# ***The Sandstone Precinct***

*State Significant  
Development  
Modification Assessment  
(SSD 7484 MOD 4)*

December 2019

**Figure 9** | Proposed portion of retained gantry balustrade, brackets and gates.

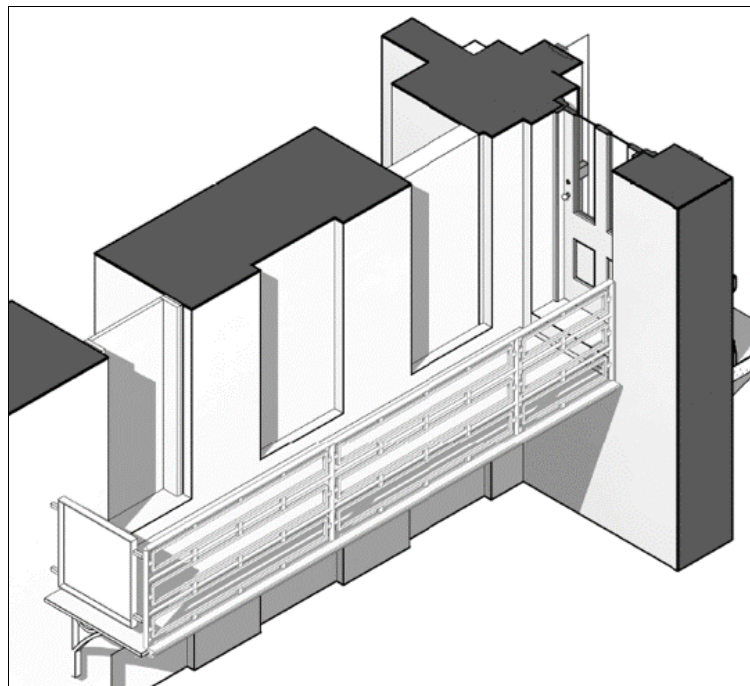
Council recommended some of the courtyard toilet structures and related iron gangways should be retained and interpreted in situ.

The Applicant has advised the majority of gangways are planned to be removed as they provided access to the toilets, which are being removed to declutter the courtyards, and the fabric is in poor structural condition. However, the revised design will retain a portion of the gangways in the north and south courtyard (using the best fabric) to be interpreted in their original position (**Figure 9**).

**Figure 10** | Strong Room section showing proposed restored volume (left) and proposed demolition in red (right)

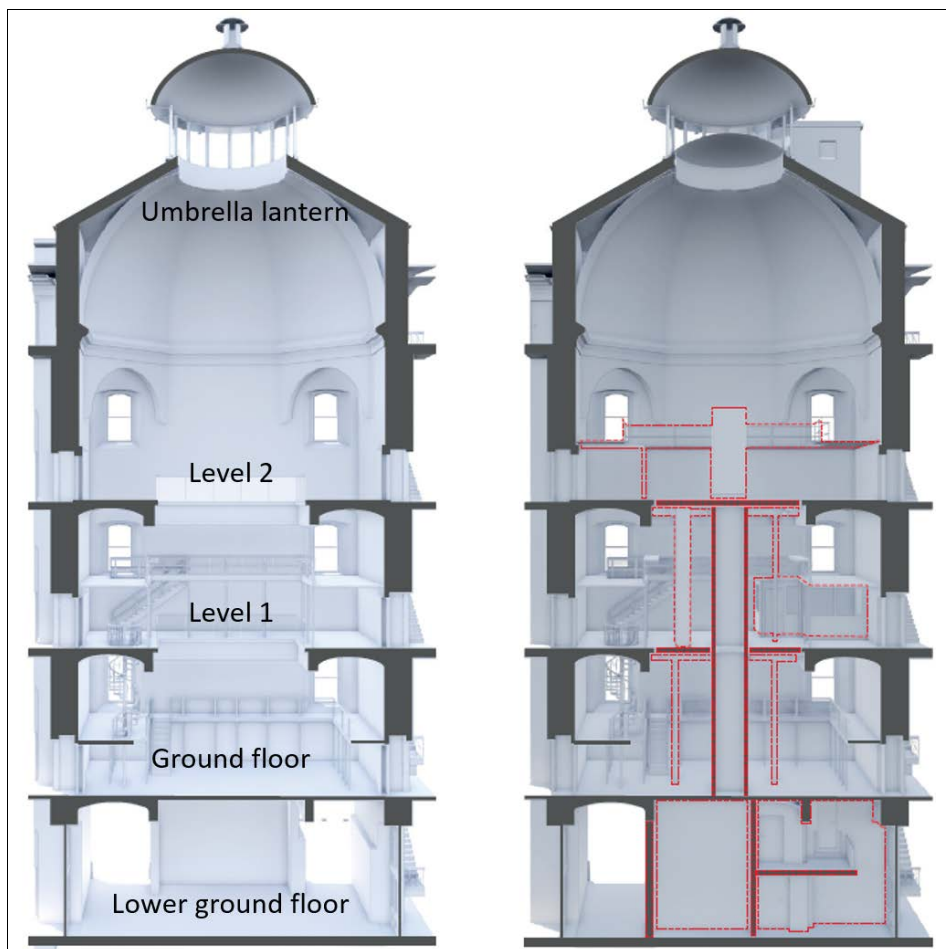
The DRP advised they did not support the removal of the ground floor of the Strong Room. However, the Applicant has clarified that the existing Strong Room ground floor is being retained and the proposal focuses on returning the Strong Room to its original volume by removing intrusive floors introduced in the 1950s (**Figure 10**).

**Figure 11** | Proposed link insertions, with glazed elevations facing the courtyard

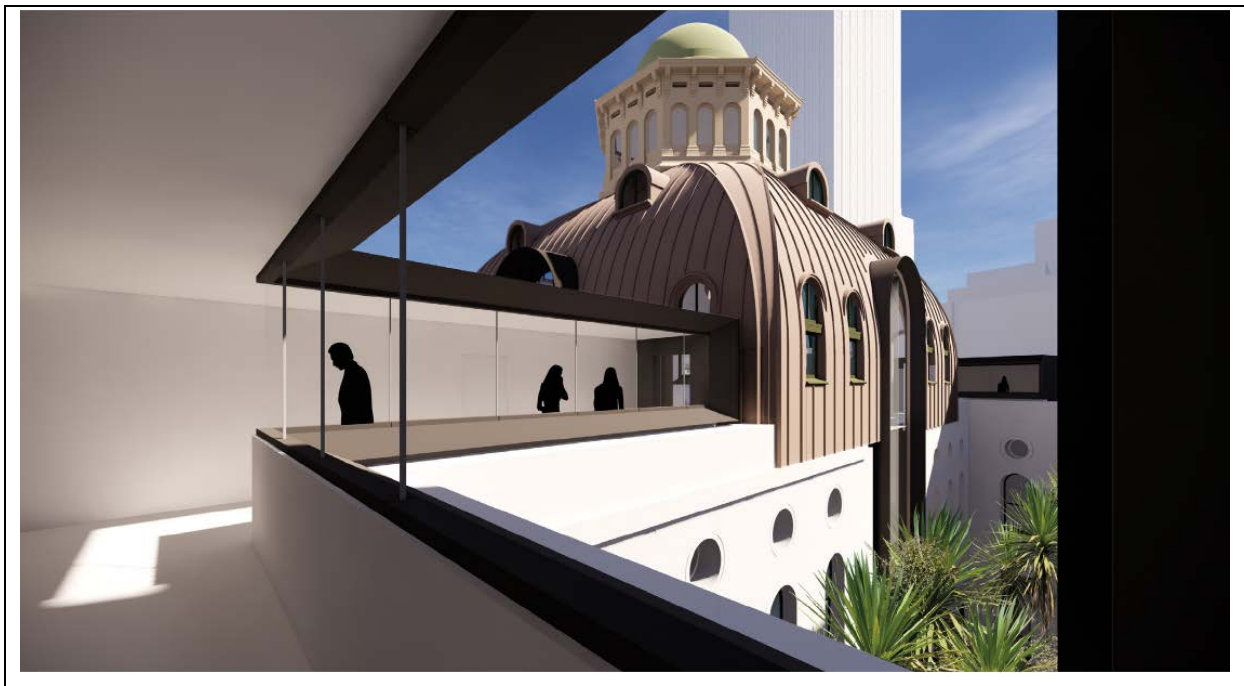
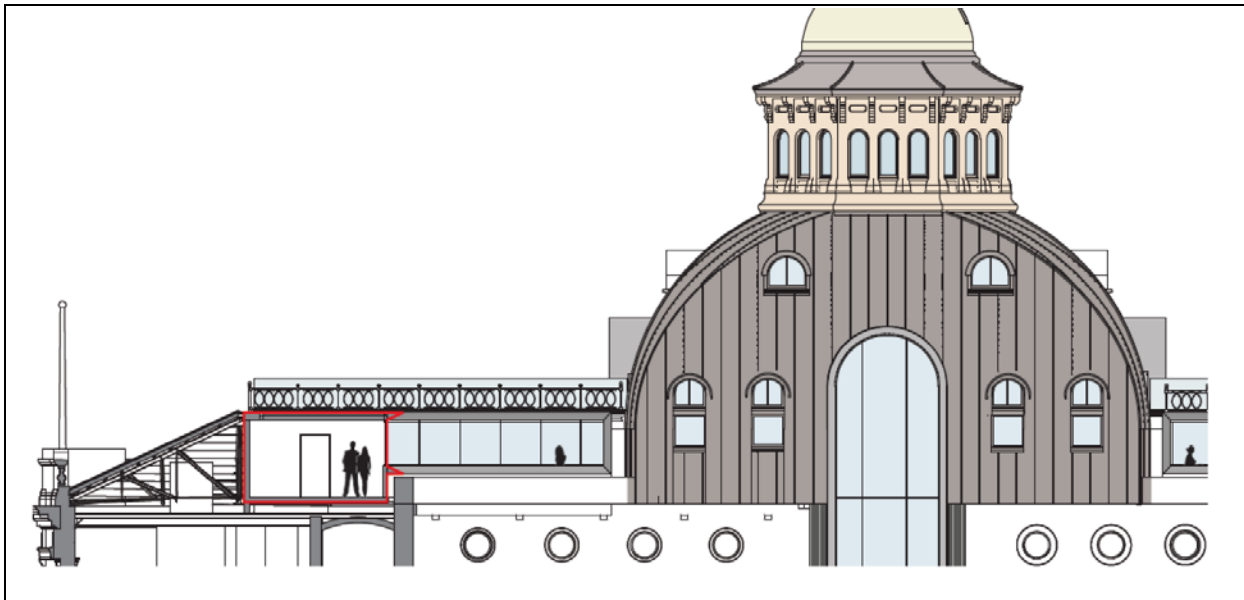
The DRP supports the new roof strategy and the new links within the height of the existing roof, however it considers that the links should be pulled back from the edge of the courtyard, so they are not visible from the courtyard and increase sun and light into the courtyard.

The Applicant advises the links are designed to be reversible and have minimal visual impact. To address the concerns raised by the DRP, the Applicant advises the corridors are to have glazed elevations facing the courtyard and the links are pulled away from the sides of the Northern Dome and Tempietti (**Figures 11 and 12**).

The Department supports the link insertions as:

The Department also recommends existing Condition B9 be amended to require detail drawings of the roof works be submitted to NSW Heritage prior to issuing the nominated construction certificate. Subject to the recommended condition the Department is satisfied the proposed works are acceptable.

**Figure 13** | Farrer Place drop off and pick up bay

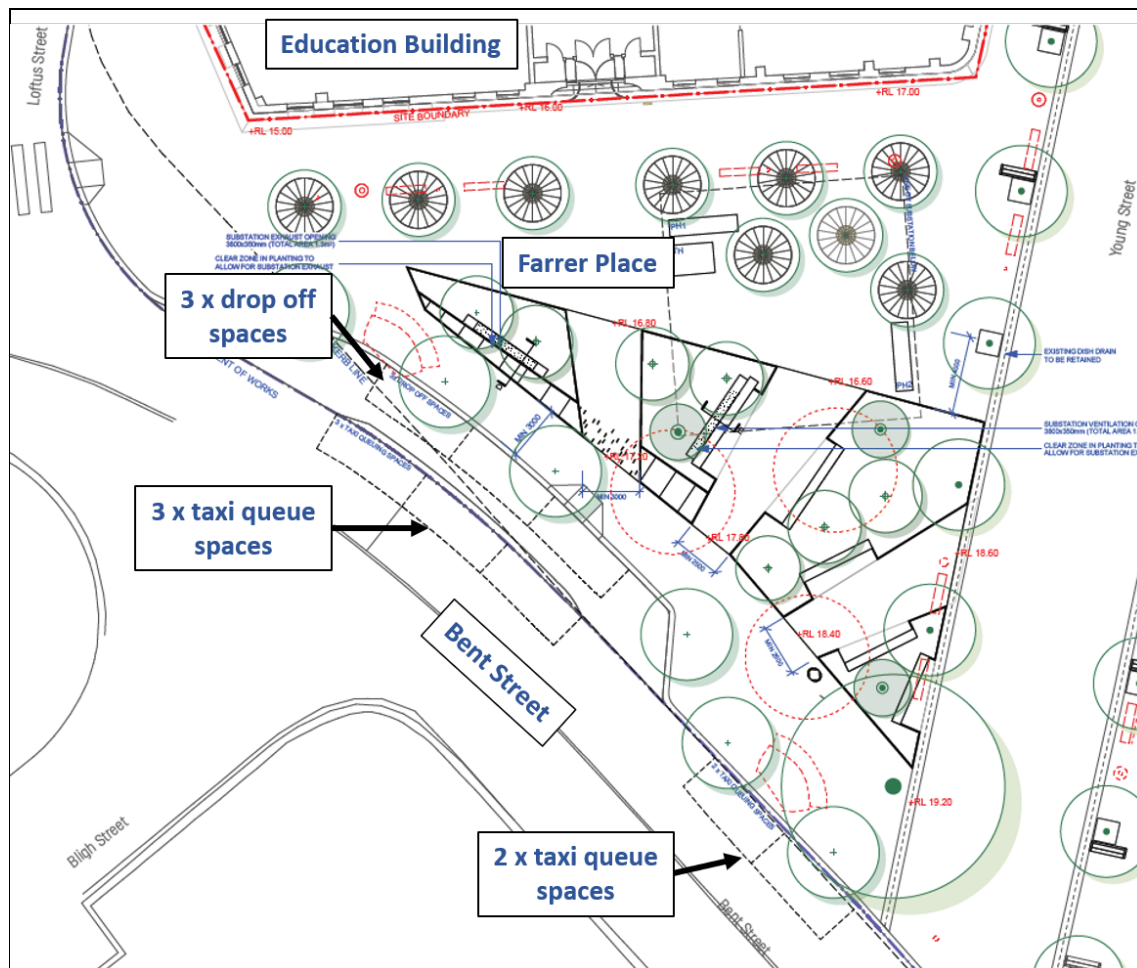
- details of the adequacy of the loading dock, passenger pick up and drop off arrangements and cumulative impacts, noting the ballroom location and capacity is proposed to be changed
- an updated Construction Pedestrian and Traffic Management Plan (CPTMP) to reflect the proposed modification, should be submitted to the Coordinator General, Transport Coordination for endorsement, through an amended condition.

The Department notes a new vehicular drop-off on Farrer Place, adjacent to Bent Street was approved by the City of Sydney in development application D/2016/1641, which provides three drop off spaces, three taxi queue spaces and two taxi pick up spaces associated with the use of the Sandstone Precinct for visitor and tourist accommodation (**Figure 13**). However, during the busiest period for a function, four vehicles could be dropping off at the same time, with the drop off bay containing three spaces.

As such the Department is satisfied drop off and pick up arrangements for the proposed development can be managed effectively, subject to the preparation of a TAG, as recommended by TfNSW.
